# United States Patent and Trademark Office

APPLICATION NO. FILING DATE FIRST NAMED INVENTOR ATTORNEY DOCKET NO. CONFIRMATION NO. 10/783,479 02/20/2004 Larry D. Morris 2810 2140 36288 7590 12/27/2004 EXAMINER KENNETH H. JACK KOVACS, ARPAD F 2121 MAPLE WICHITA, KS 67213 ART UNIT PAPER NUMBER 3671

### **DETAILED ACTION**

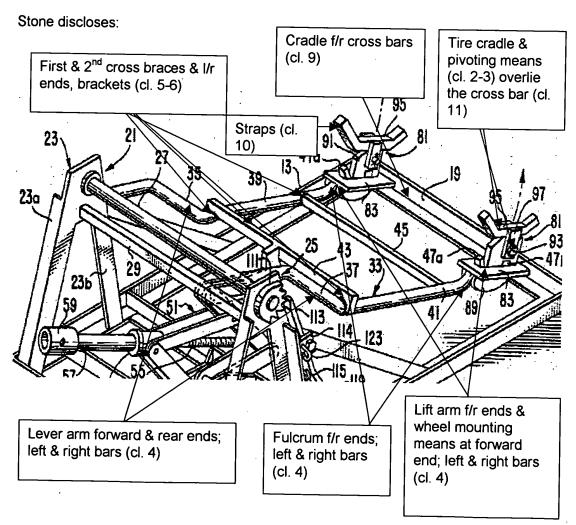
1. The drawings are objected to under 37 CFR 1.83(a). The drawings must show every feature of the invention specified in the claims. Therefore, the "left and right "D" braces ... supporting the left and right curved bars" (cl. 8) must be shown or the feature(s) canceled from the claim(s). No new matter should be entered. This feature was not treated on the merit.

In re Drawings: Examiner would further point out that the reason D braces are not shown as claimed, because the bars at where the Applicant points to have the D braces, are not "curved."

Corrected drawing sheets in compliance with 37 CFR 1.121(d) are required in reply to the Office action to avoid abandonment of the application. Any amended replacement drawing sheet should include all of the figures appearing on the immediate prior version of the sheet, even if only one figure is being amended. The figure or figure number of an amended drawing should not be labeled as "amended." If a drawing figure is to be canceled, the appropriate figure must be removed from the replacement sheet, and where necessary, the remaining figures must be renumbered and appropriate changes made to the brief description of the several views of the drawings for consistency. Additional replacement sheets may be necessary to show the renumbering of the remaining figures. The replacement sheet(s) should be labeled "Replacement Sheet" in the page header (as per 37 CFR 1.84(c)) so as not to obstruct any portion of the drawing figures. If the changes are not accepted by the examiner, the applicant will be notified and informed of any required corrective action in the next Office action. The objection to the drawings will not be held in abeyance.
